Technical Service Bulletin: TSB200057

Fractured Low Temperature Aftercooler Water Pump Shaft

- QST30 CM552

Figure 1, Fractured Low Temperature Aftercooler Water Pump Shaft.

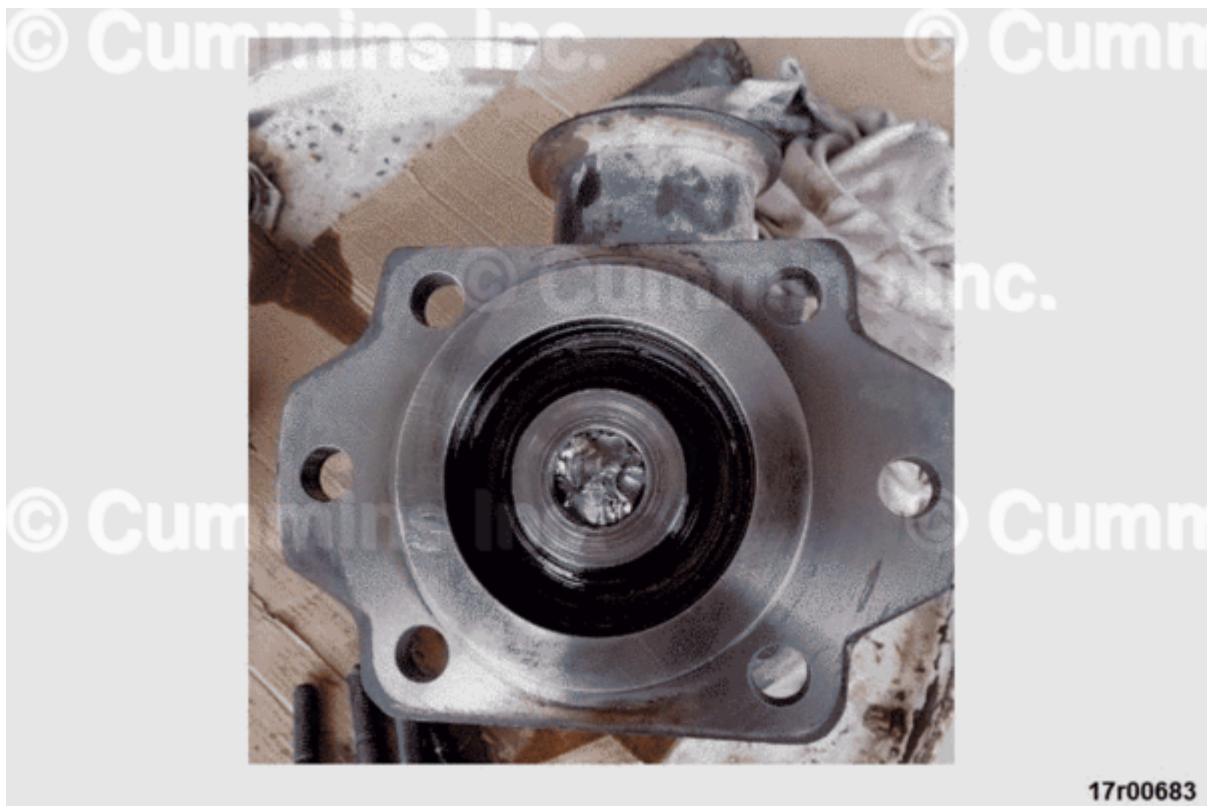
Symptom:

- High intake manifold temperature.

Root Cause:

- Fractured low temperature aftercooler water pump shaft.

Inspect low temperature aftercooler water pump shaft. See Figure 1 below.

Figure 2. New Low Temperature Aftercooler Water Pump Mounting Arrangement.

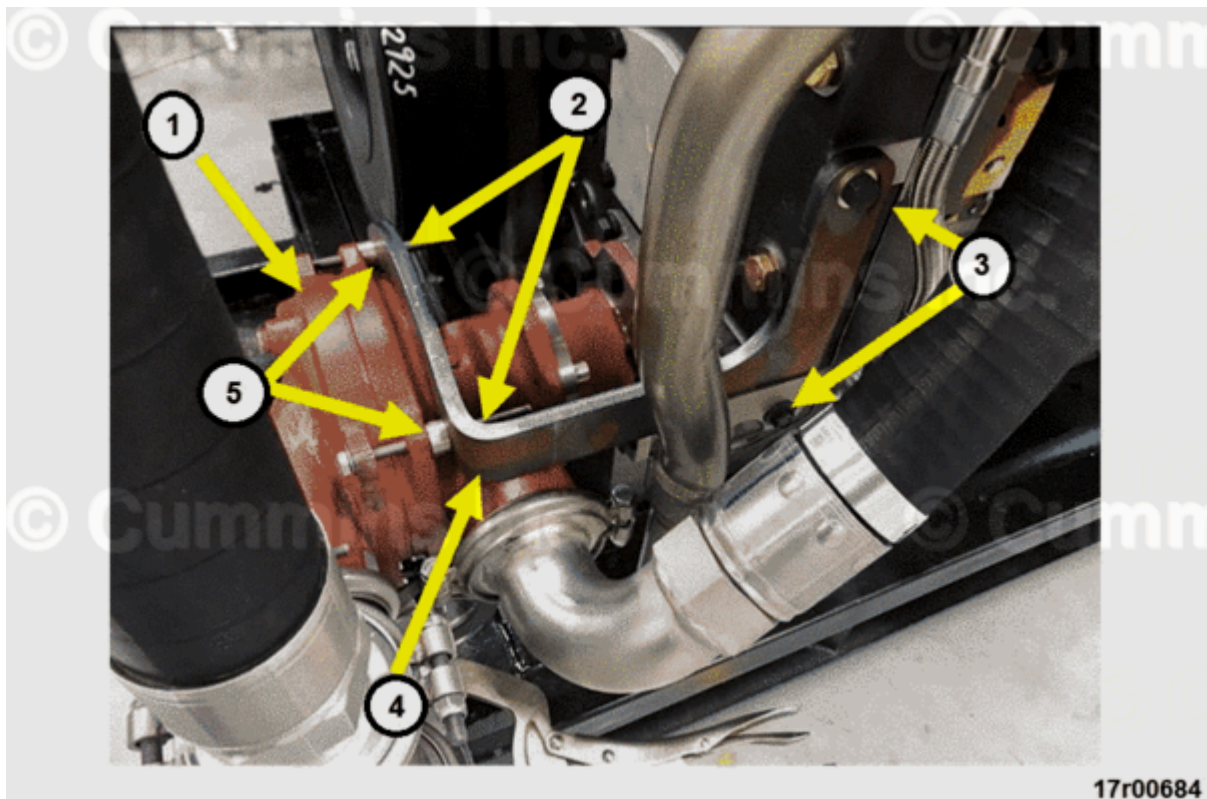
A new water pump and water pump brace were released. See Figure 2 below for new mounting arrangement.

Install two mounting spacers (5) between the water pump housing (1) and water pump brace (4).

Install water pump brace mounting capscrews (2).

- Torque Value: 65 N•m [48 ft-lb]

Install water pump brace mounting capscrews (3).

- Torque Value: 33 N•m [24 ft-lb]
